ARCHITECT'S ADDENDUM

Addendum Number: 03

RE: EAHS 2026 Secured Entrance

Subject: Addendum 03 to the Construction Documents for the East Aurora High School 2026 Secured Entrance Project.

SF-1

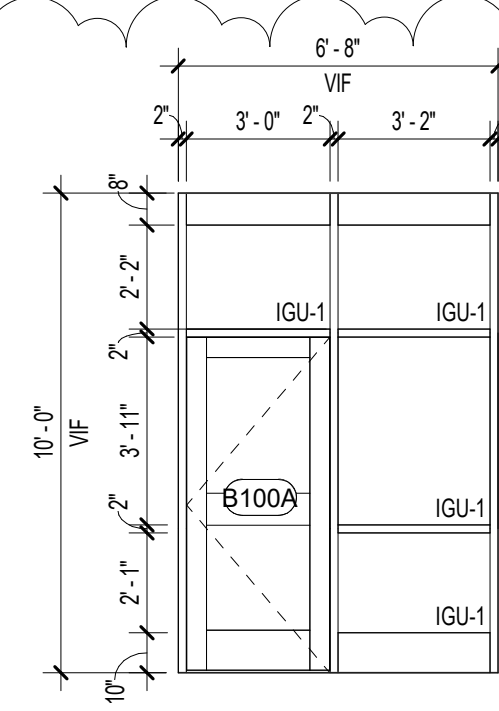
- 1) Sheet A1.00 – Partial First Floor Plan – Area B
 - **REVISED** Existing Conditions Photograph, Elevations, and New Work Plan. Refer to clouded regions on the attached drawing sheet.
- 2) Sheet A2.00 – Interior Elevations, Storefront Elevations, Wall Types, & Details
 - **REVISED** Glazing Notes and Legend, Alternate Descriptions, Storefront Elevations, and Detail 5 – Typical Header Detail – Main Entrance. Refer to clouded regions on the attached drawing sheet.

LAMINATED CLEAR INSULATED GLAZING UNIT. REFER TO SPECIFICATIONS. LAMINATED GLAZING TO BE BASE BID.

NON-LAMINATED INSULATED CLEAR GLAZING UNIT.
REFER TO SPECIFICATIONS. REFER TO ALTERNATES.

ALTERNATE #01 - FURNISH AND INSTALL NON-LAMINATED INSULATED GLAZING IGU-3 IN LIEU OF LAMINATED GLAZING IGU-1. FURNISH AND INSTALL 3M SAFETY SECURITY WINDOW FILM OR EQUAL.

ALTERNATE #02 - FURNISH AND INSTALL NEW STOREFRONT (BEYOND VESTIBULE, FROM GRIDLINE 30 EASTWARD, ROUGHLY 53 FEET) AS SHOWN ON SHEET A1.00.

ALTERNATE #02A - FURNISH AND INSTALL NON-LAMINATED INSULATED GLAZING IGU-3 IN LIEU OF LAMINATED GLAZING IGU-1. FURNISH AND INSTALL 3M SAFETY SECURITY WINDOW FILM OR EQUAL FOR ALTERNATE 2 STOREFRONT LOCATIONS.

○ TYP. ROOF DETAIL AT EQUIPMENT SUPPORT
NOT TO SCALE

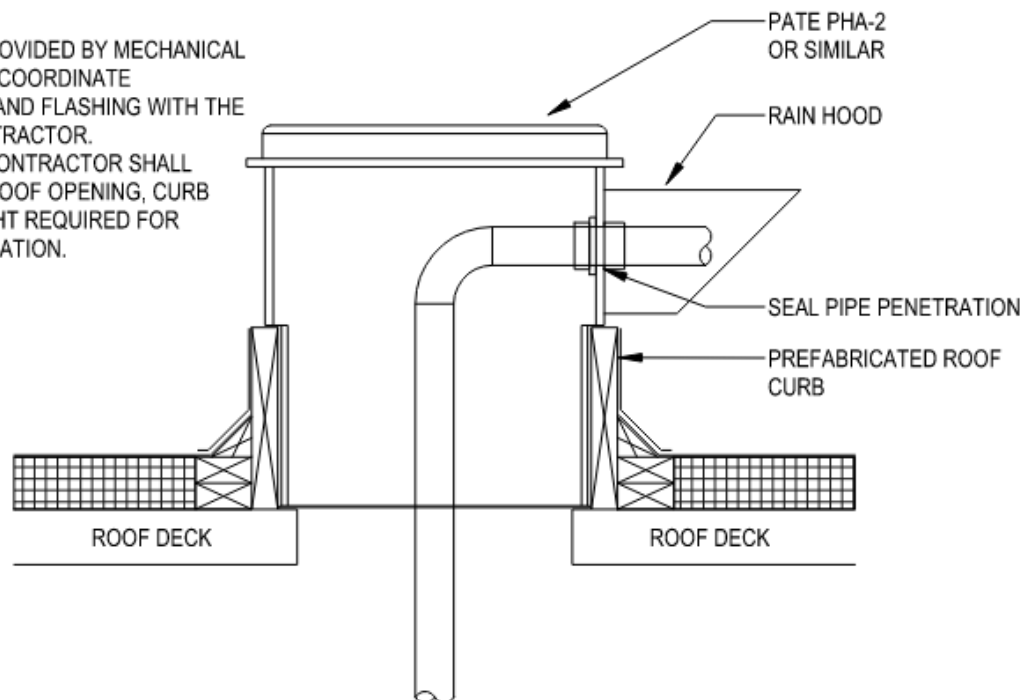
2	Lite Construction	Whether or not we need to incorporate any additional steel support for CU-1 or whether a Thybar system like the attached would be sufficient? PDFs have been attached for reference.			8/18/2026	8/21/2026	TEMS rails will work for the CU. Piping and Consuit should be routed through pipe curb as shown on attached drawing reference, see ADD03_ASK01.

1. ROOF CURB PROVIDED BY MECHANICAL CONTRACTOR. COORDINATE INSTALLATION AND FLASHING WITH THE GENERAL CONTRACTOR.
2. MECHANICAL CONTRACTOR SHALL COORDINATE ROOF OPENING, CURB SIZE AND HEIGHT REQUIRED FOR PIPING PENETRATION.
